BASE DOCUMENT: X-330 75-A, REV. 2 CAD OVERLAY

DOCUMENT: X-370-4022-E, REVISION: 0 CAD OVERLAY

HEATING AND VENTILATING
GROUND FLOOR X-29 UNIT NUMBER 3
X-330-112M

FILE X-630 DEACTIVATION NEW RECIRCULATING COOLING WATER (RCW) HEADER FOR X-330
--

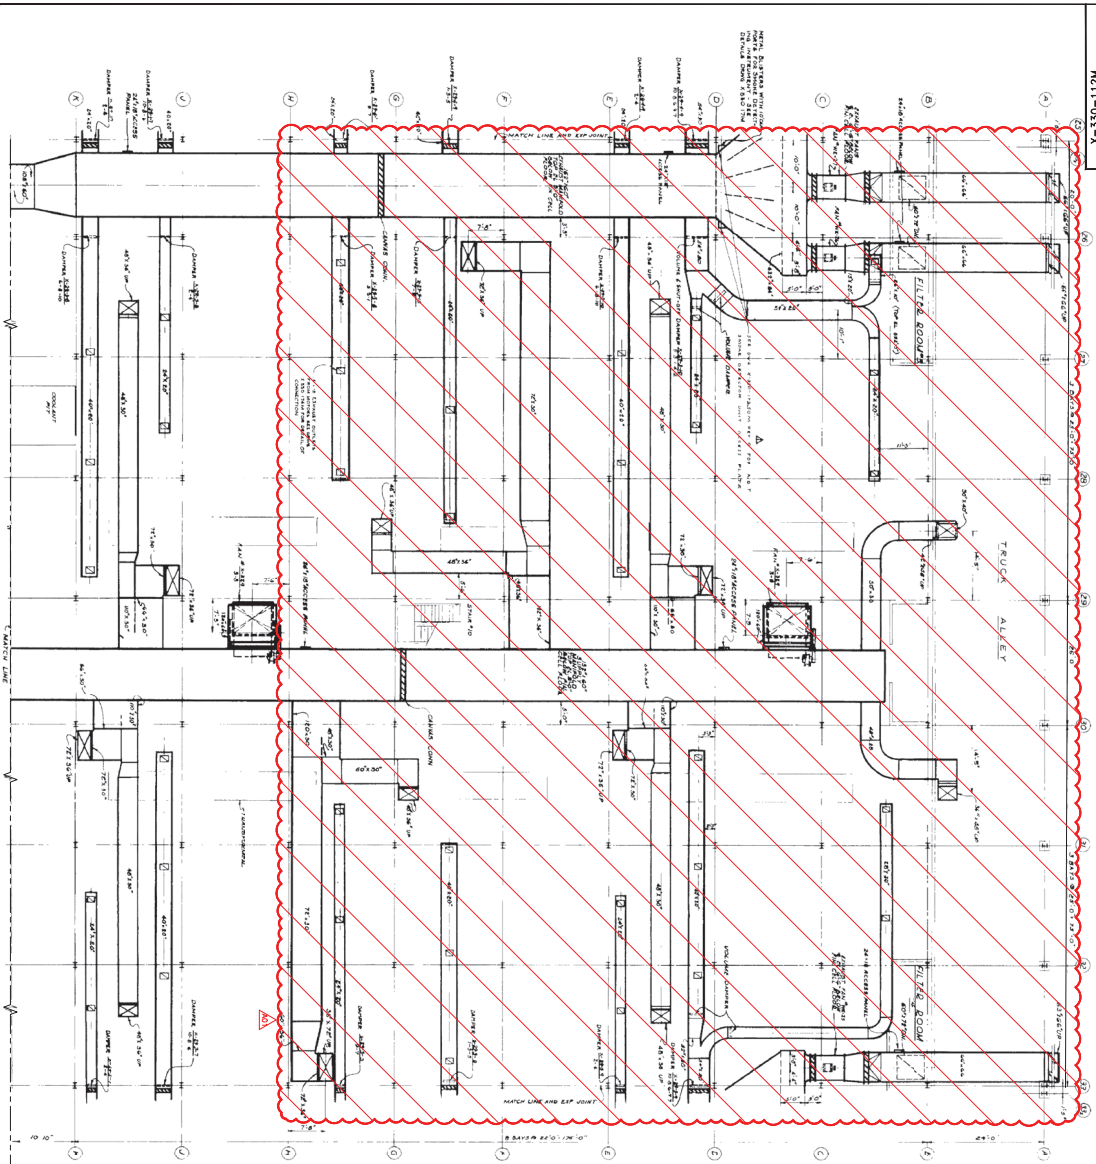
REVISION NOTE

1. ALL ROOMS AND AREAS WITHIN ROOM 1 AND 17-20 TO BE REMOVED AND REPLACED WITH EXISTING ROOMS.
2. FLOOR ROOM 2, 3, AND 4 TO BE REMOVED AND FLOOR IN.
3. REMOVAL TO BE REMOVED UNDER SPECIFICATION 40.

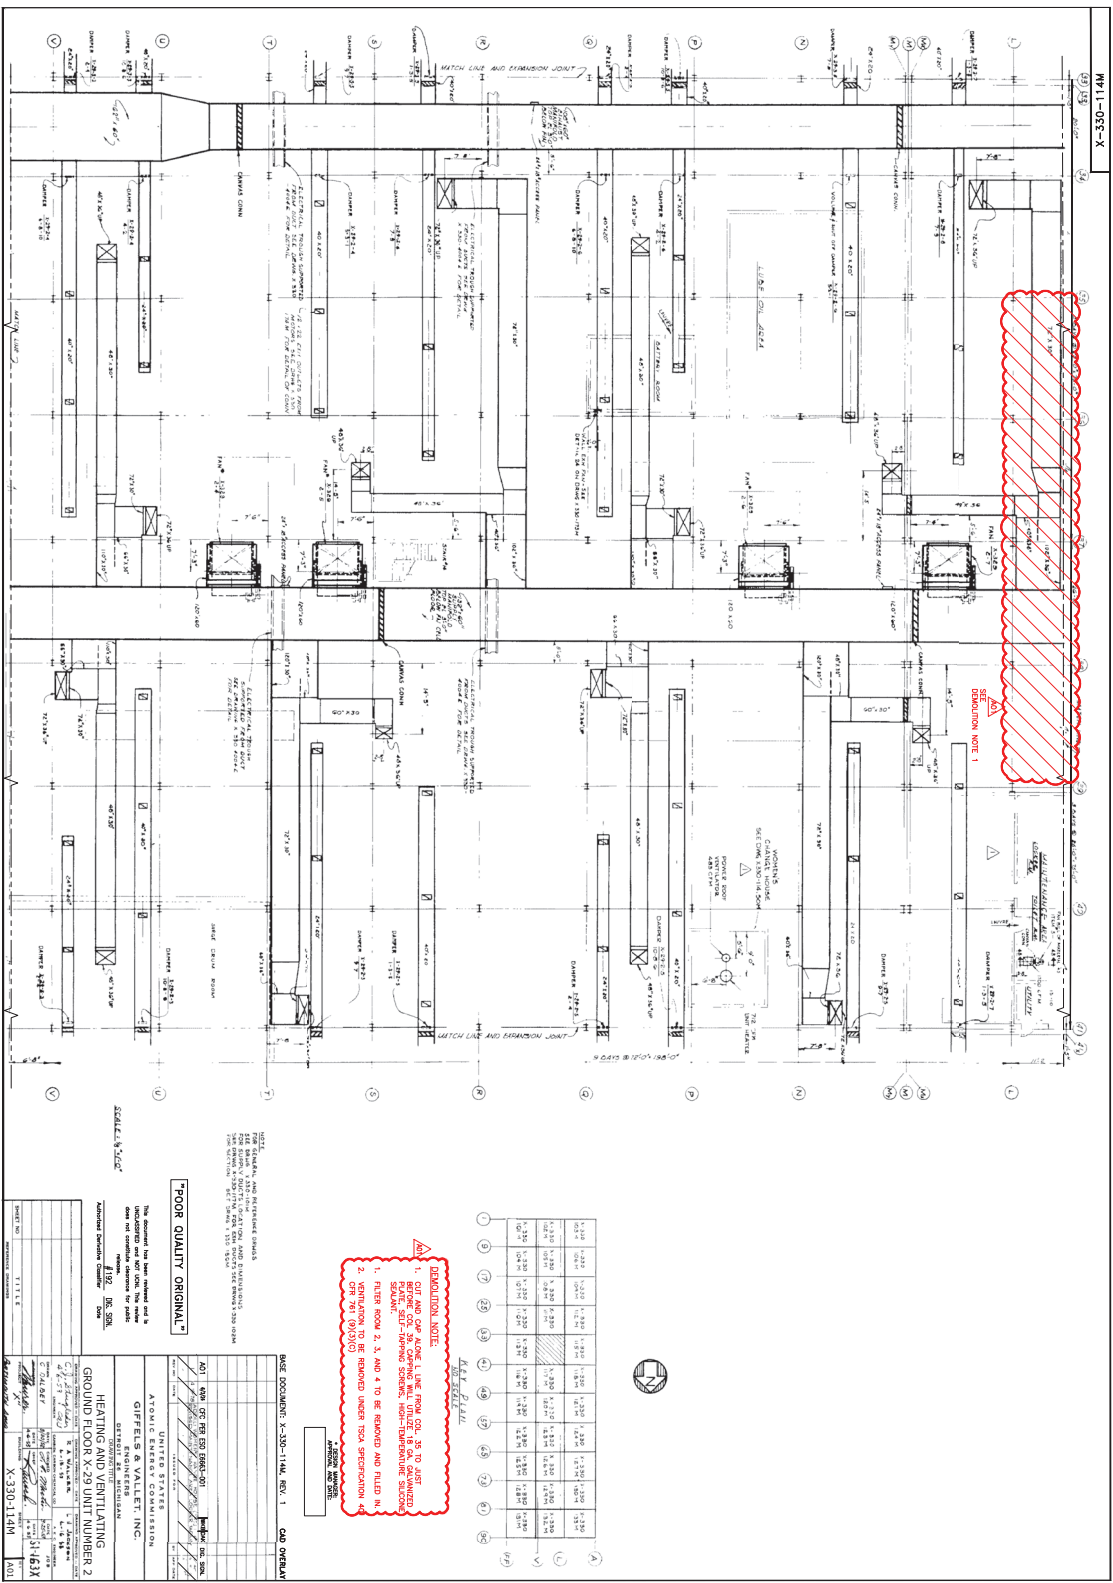
DEMOLITION NOTICE

1. ALL VENTILATION DUCT WITHIN GRID A-H AND 17-38 TO BE REMOVED AND CAPPED. CAPPING WILL UTILIZE 18 GA. GALVANIZED PLATE, SELF-DIPPING SCREWS, HIGH-TEMPERATURE SILICONE SEALANT.
2. FILTER ROOM 2, 3, AND 4 TO BE REMOVED AND FILED IN.
3. VENTILATION TO BE REMOVED UNDER TSCA SPECIFICATION 40 CFR 761.6(b)(3)(C)

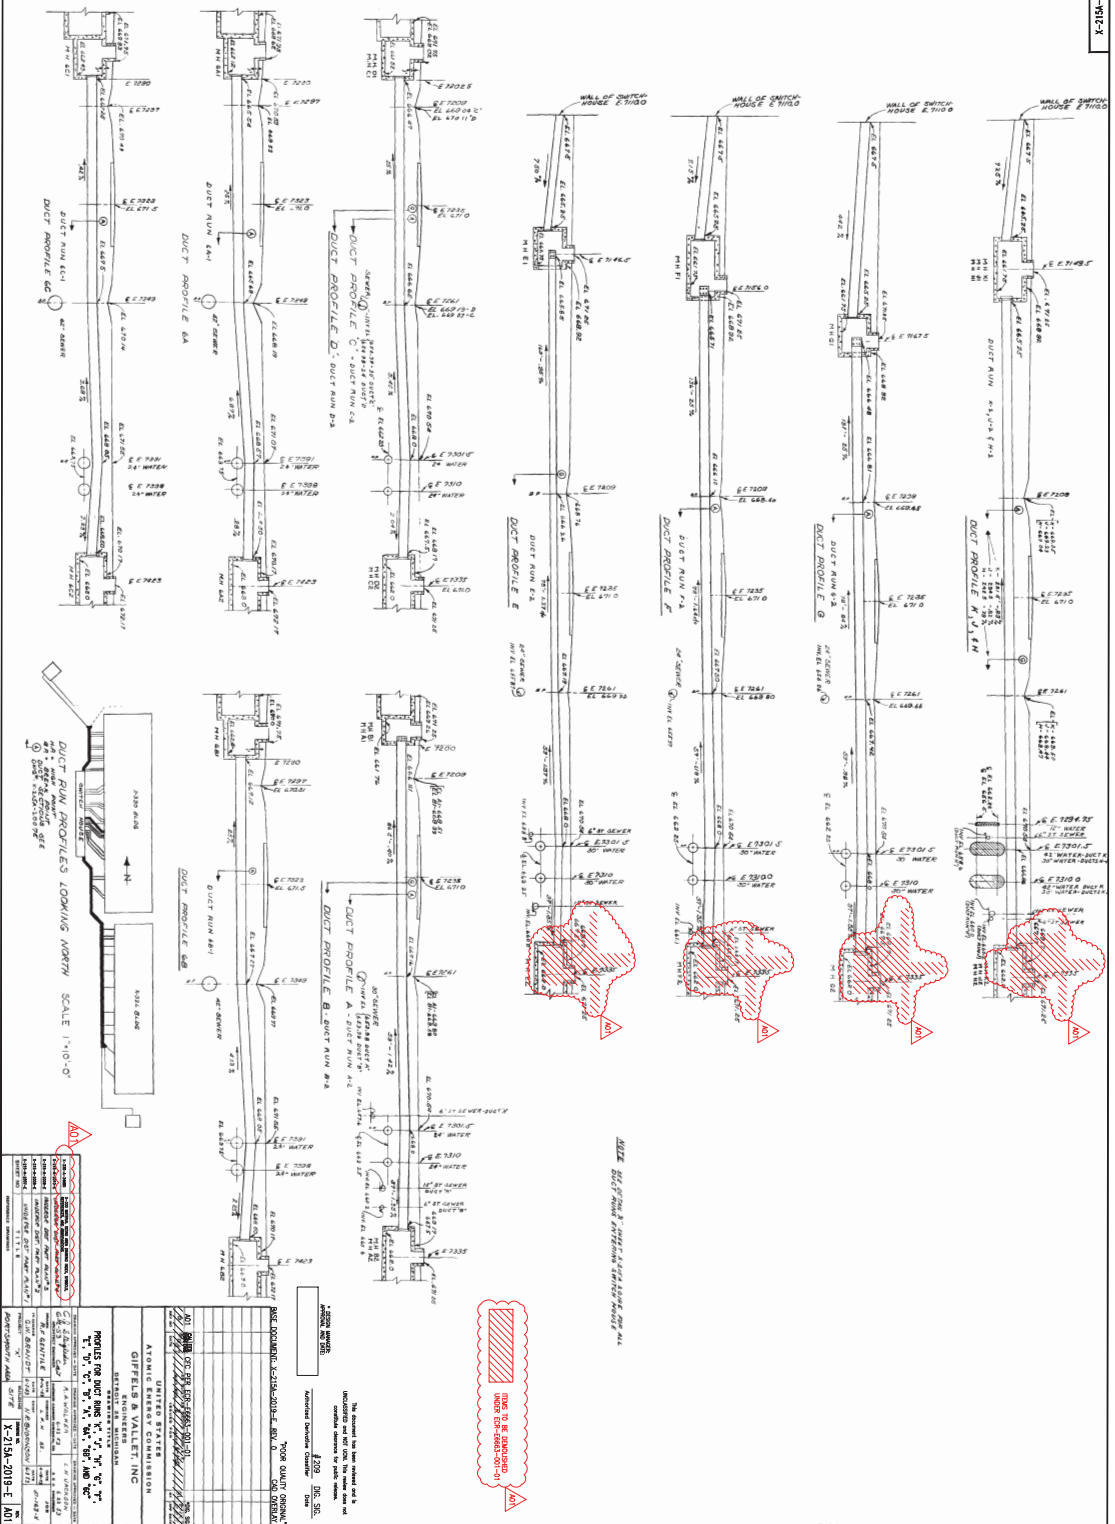
- REVISION NOTES**
1. FROM TO ANY CORRECTION - VERIFY ALL DIMS. HAVE BEEN
 2. ALL CONDUIT SPANNING LOCATED WITHIN THE MARKED DRAINAGE AREA ARE TO BE REMOVED AND 4'-0" DIA.
 3. ADDING THE CONDUIT BANK WHERE DUCT BANKS EXIST IS CORRECTED

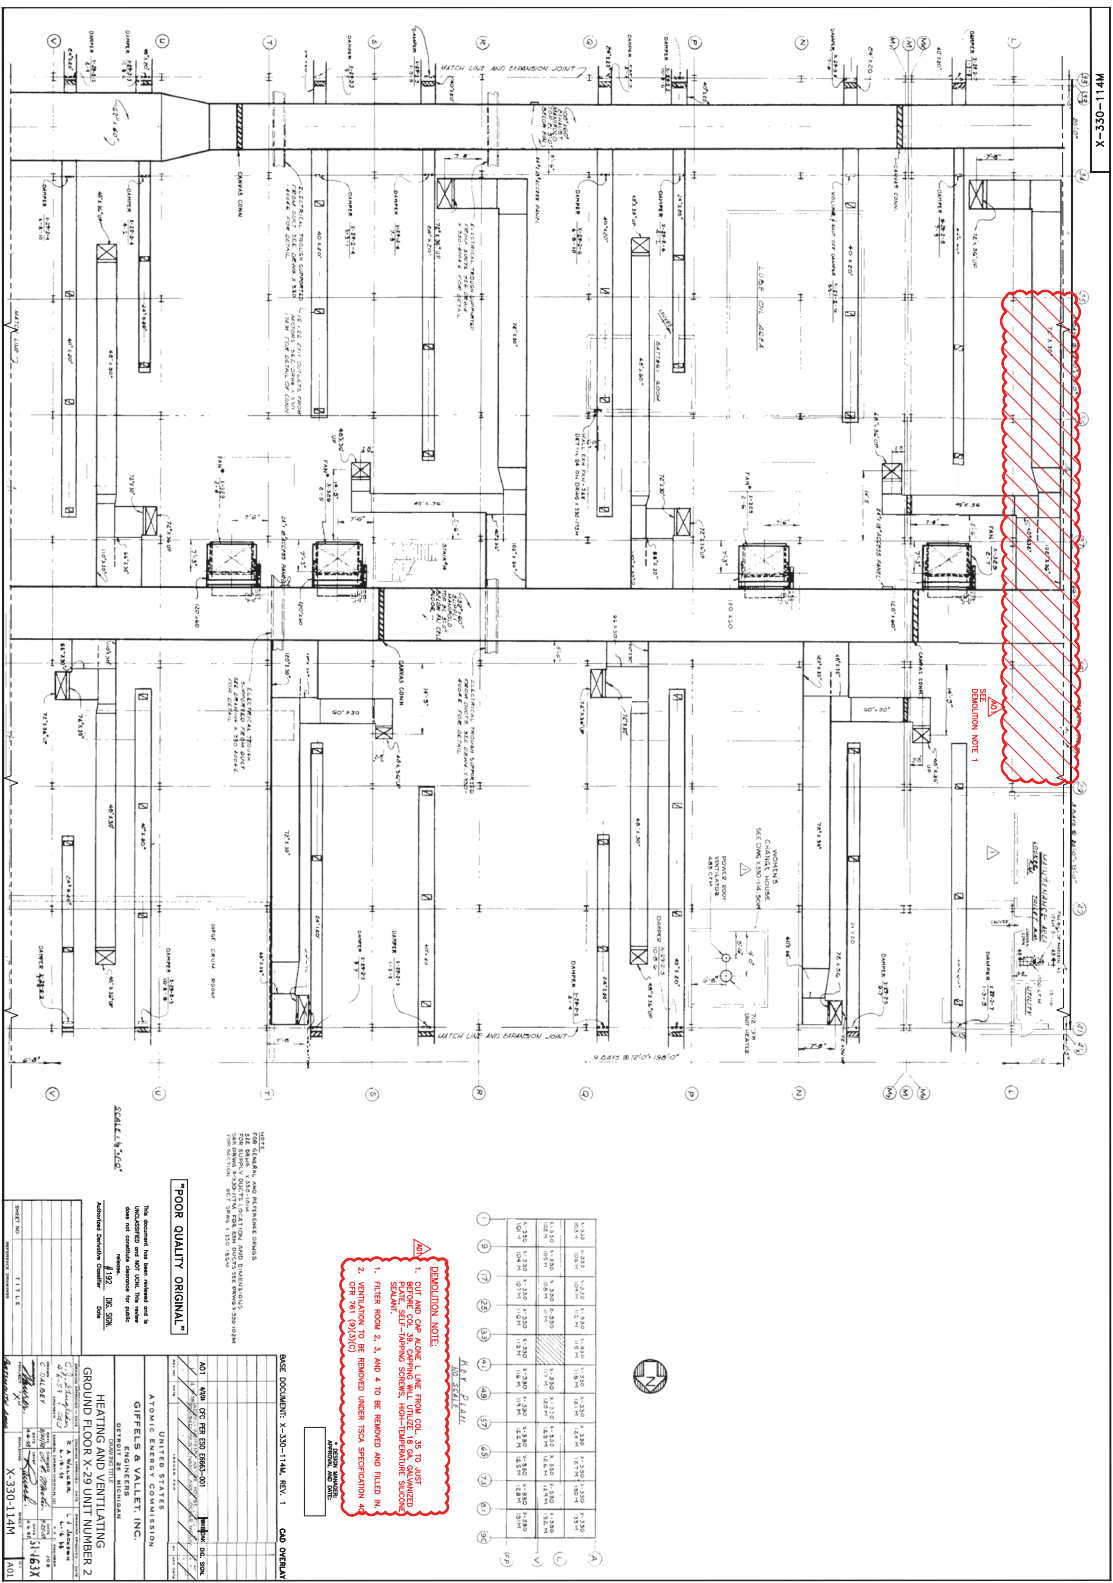
DEMOLITION NOT

1. ALL VENTILATION DUCT WITHIN GRID A-H AND 17-38 TO BE REMOVED AND CAPPED. CAPPING WILL UTILIZE 18 GA. GALVANIZED PLATE, SELF-DIPPING SCREWS, HIGH-TEMPERATURE SILICONE SEALANT.
2. FILTER ROOM 2, 3, AND 4 TO BE REMOVED AND FILED IN.
3. VENTILATION TO BE REMOVED UNDER TSCA SPECIFICATION 40 CFR 761.6(a)(3)(C)

UNDERGROUND PIPING KEY PLAN #2

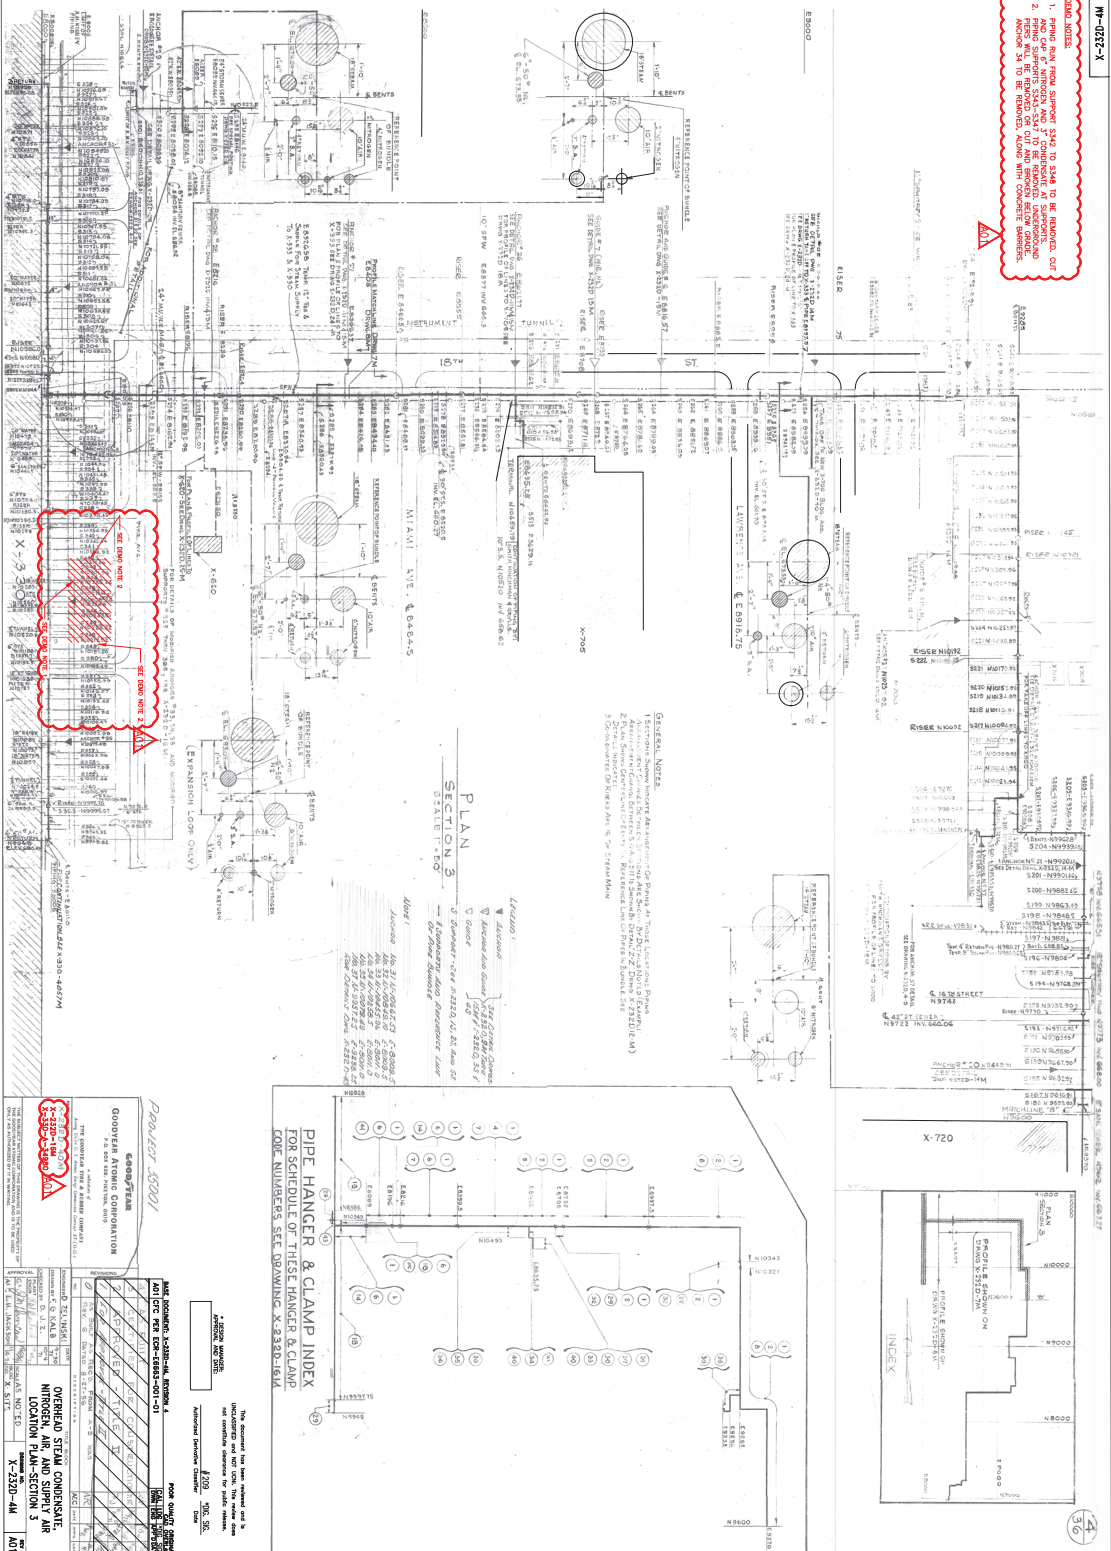
1. PIPING RUN FROM SUPPORT S342 TO S348 TO BE REMOVED. CUT AND CAP 6" NITROGEN AND 3" CONDENSATE AT SUPPORTS.
2. PIPING SUPPORTS S343-S347 TO BE REMOVED. UNDERGROUND PIPES WILL BE REMOVED OR CUT AND BROKEN BELOW GRADE. ANCHOR 34 TO BE REMOVED, ALONG WITH CONCRETE BARBERS.

- REVISION NOTES:**
1. AM BLDG PIPING TO BE DEMOLISHED TO WALK WALL. PIPING IS TO BE
 2. AM BLDG PIPING TO BE DEMOLISHED TO A MINIMUM OF 2' BELOW
 3. SEE TO DEMOLISH 1-400-1-200-1 FOR WALK WALLS.

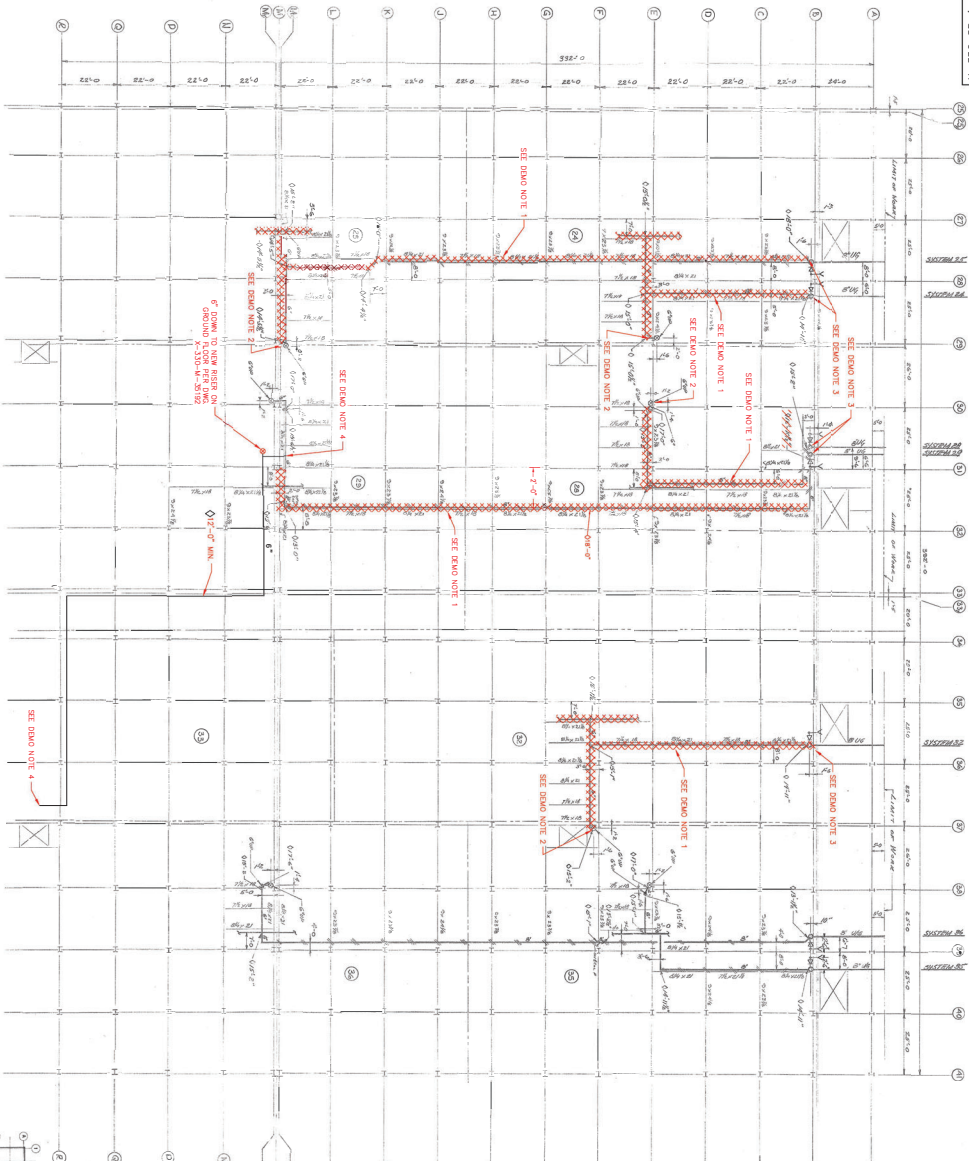
- REMARKS:**
1. REMOVE ALL EXIST. MAIN, RISER, PUMP, SPRINKLER HEADS, AND PIPE UNLESS SHOWN OTHERWISE.
 2. REMOVE ALL EXIST. SPRINKLER PIPING UNLESS SHOWN OTHERWISE.
 3. REMOVE ALL EXIST. SPRINKLER PIPING IN SPARKER CABINET CAN BE REMOVED. SEE 4. FOR DETAILS.
 4. REMOVE ALL EXIST. SPRINKLER PIPING IN SPARKER CABINET CAN BE REMOVED. SEE 4. FOR DETAILS.
 5. REMOVE ALL EXIST. SPRINKLER PIPING IN SPARKER CABINET CAN BE REMOVED. SEE 4. FOR DETAILS.
 6. FINE C&M ANY C&M IN REMOVED SYSTEMS.
 7. SPRINKLER SYSTEM SHALL NOT BE REMOVED UNTIL APPROVED BY THE SUPERVISOR OF REMOVAL.

SPRINKLER LAYOUT - GROUND FLOOR
UNDER DUCTS

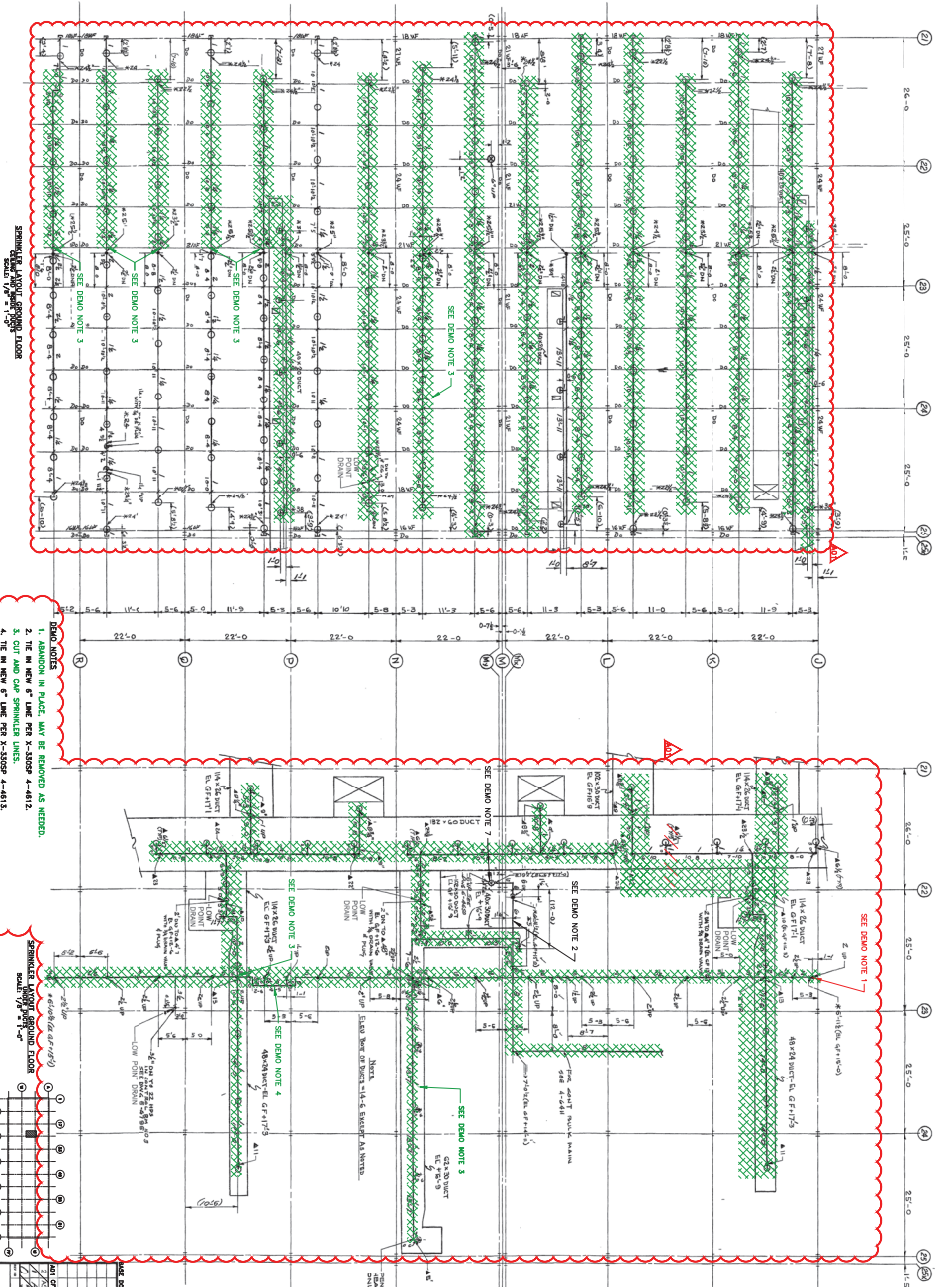
1. CUT CAP, AND REMOVE ALL RESERS, PIPES, SPRINKLER HEADS, AND PIPE HANGERS LOCATED UNDER DUCT WORK. DUCT WORK IN THIS AREA IS TO BE REMOVED PERMANENTLY DURING DEMOLITION PHASE.
